**From:** [Hingtgen, Robert J](#)  
**To:** ["Asha Bleier"](#)  
**Subject:** 3910 120005, Soitec Solar Development  
**Date:** Thursday, December 20, 2012 2:16:14 PM  
**Attachments:** [ArmyCorp-12142012.pdf](#)  
[Caltrans-12142012.pdf](#)  
[Soitec Solar Projects PEIR Tisdale comments 12-18-12.pdf](#)  
[DrSamMilham-12132012.pdf](#)  
[NAHC-12182012.pdf](#)  
[SDArchSoc-12182012.pdf](#)  
[USFWS-12172012.pdf](#)

Planning and  
Development Services11-SD-8  
PM 67.23  
Soitec Solar Development  
NOP DEIR

Re: SCH#2012121018 CEQA Notice of Completion; draft Environmental Impact Report (DEIR) for the "Soitec Solar Project Environmental Impact Report (LanWest, LanEast, Rugged Solar and Tierra Del Sol);" located in the Mountain Empire Planning Area including the Community of Boulevard; eastern San Diego County, California

Subject: Notice of Preparation of an Environmental Impact Report for the Soitec Solar Development Program, Unincorporated San Diego County, California

Switchgear room outlet 23 Mw 440 E beal St Niland CA

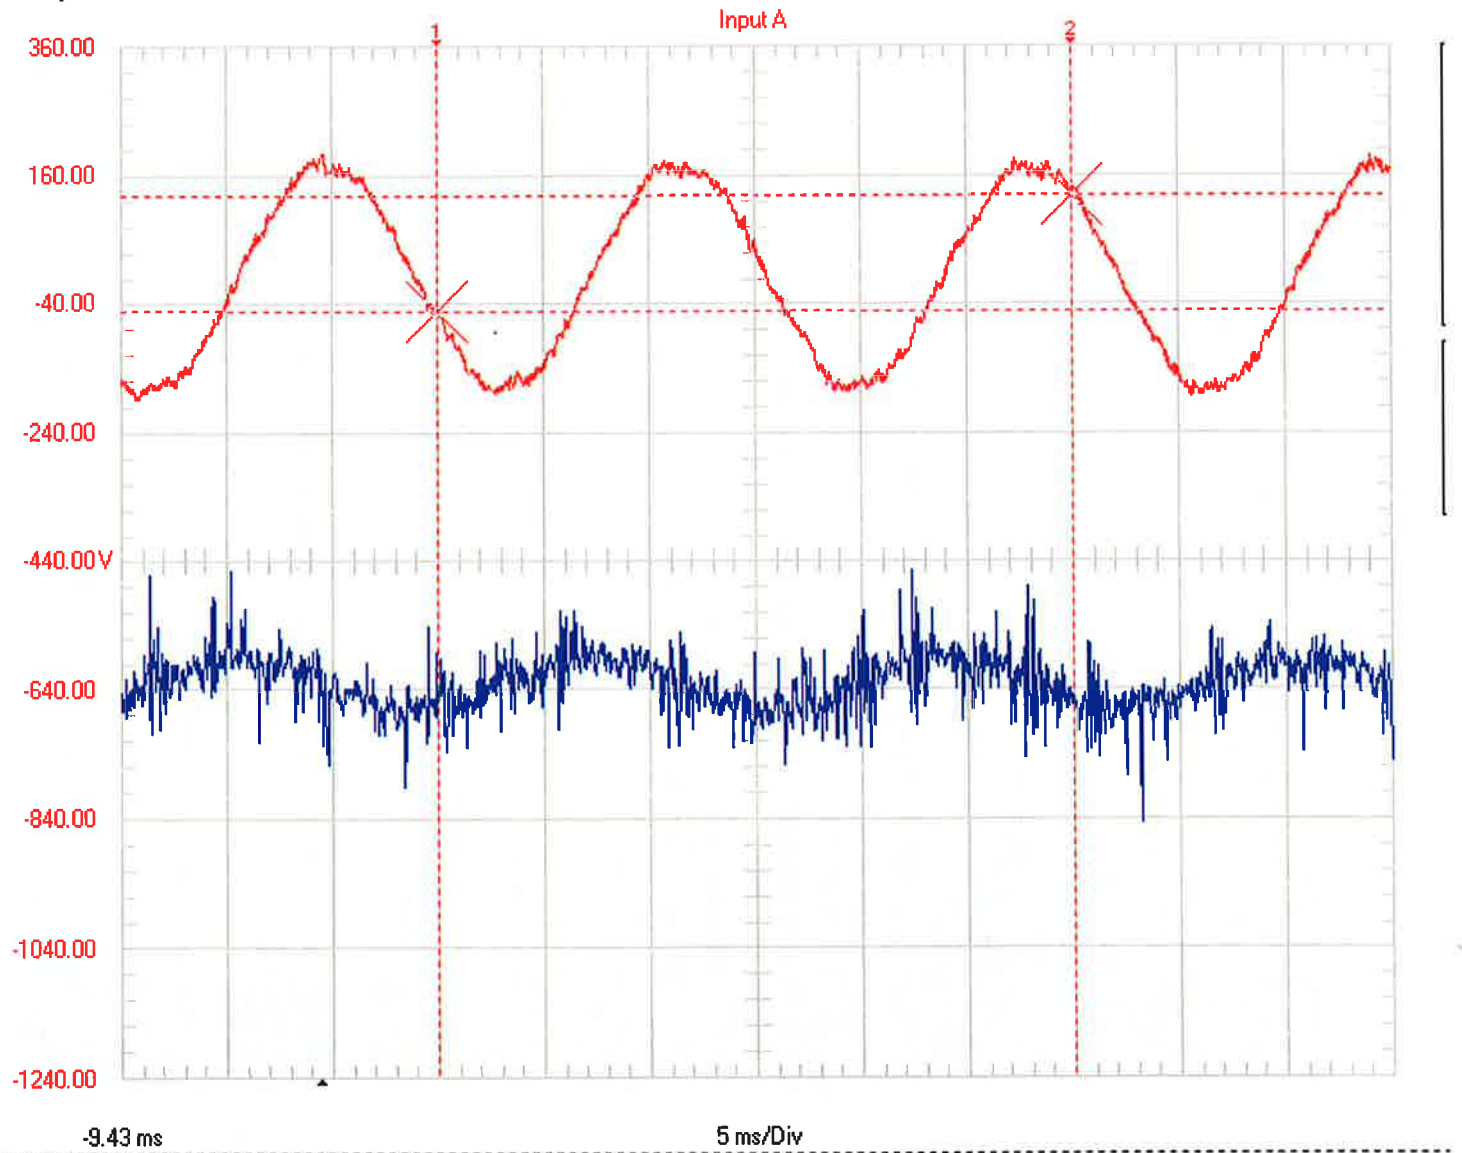
I have measured many residences with roof-top solar, and find that they all generate dirty electricity. I recently began study of a 23 megawatt solar facility near Niland CA. The inverters, switchgear room and substation were all loaded with high frequency transients. The attached oscilloscope tracings show a contaminated 60 Hz sine wave in the A block and that data block B, which has voltage passed through a high pass filter to remove the 60 Hz, has 45 V of electricity. I went through hundreds of other scope tracings I have made over the years, and found none that were above 2 V in the B block. The harmonic distortion is low, so all this electricity must be transients. I enlarged that blue curve and found that the transients' primary frequency is 20 KHz.

Inverter outlet solar array Niland CA

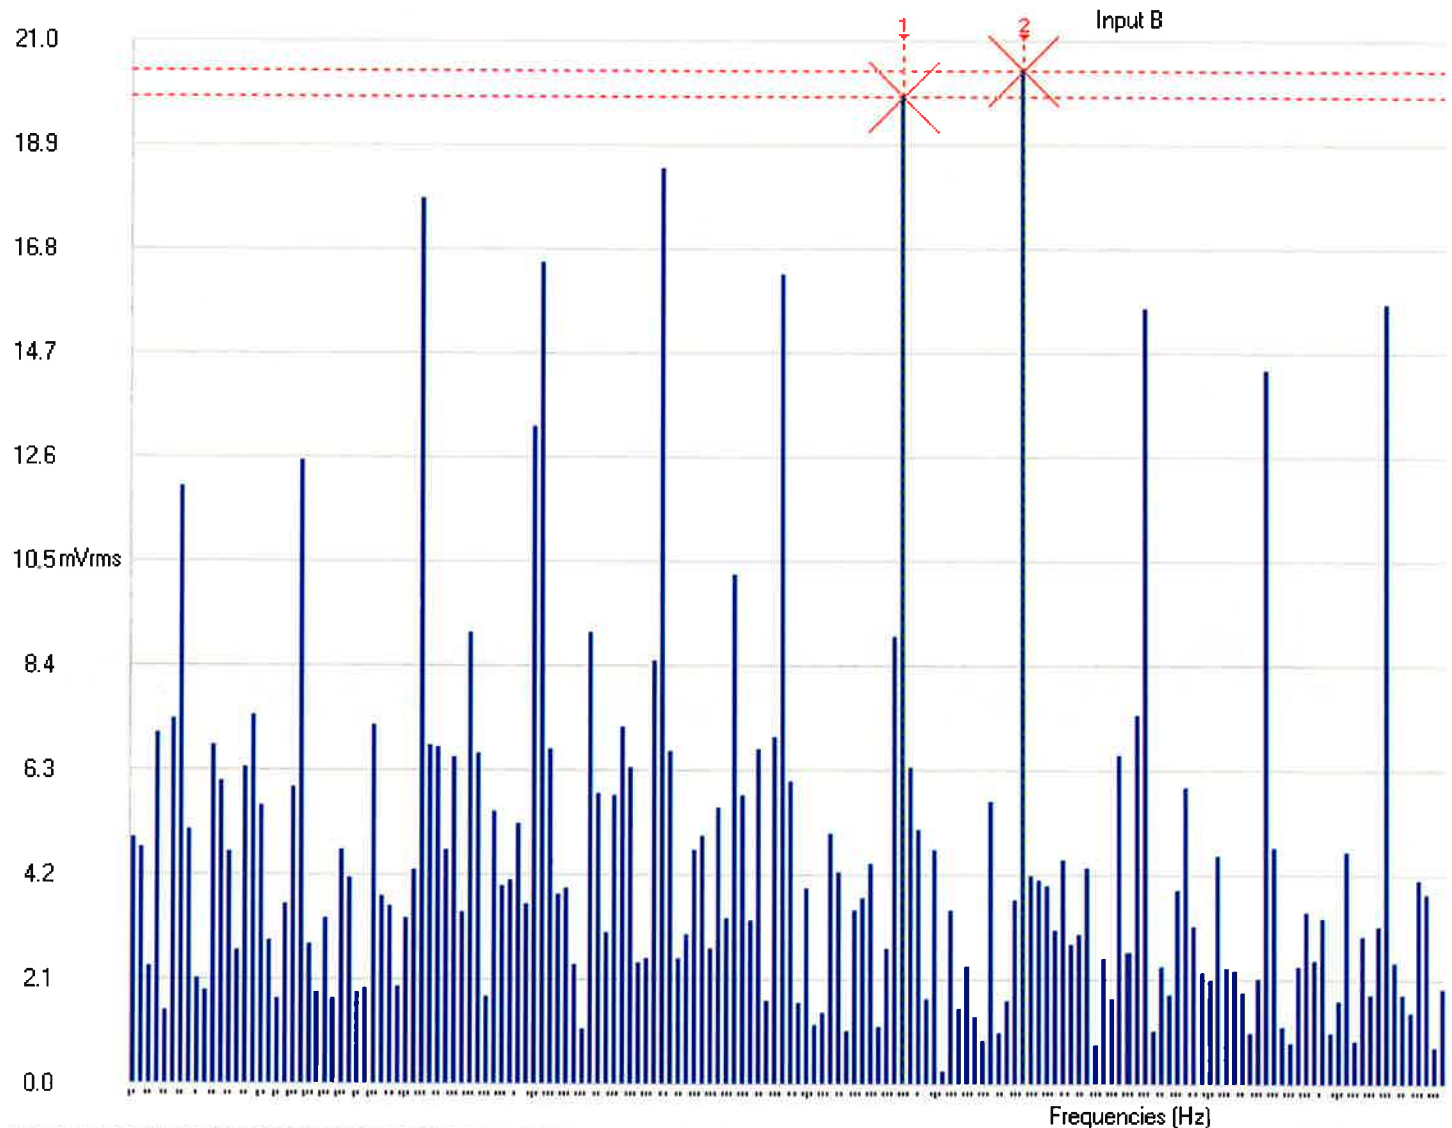
A similar pattern is seen in an outlet in an inverter with 97 volts of electricity in the high frequencies:
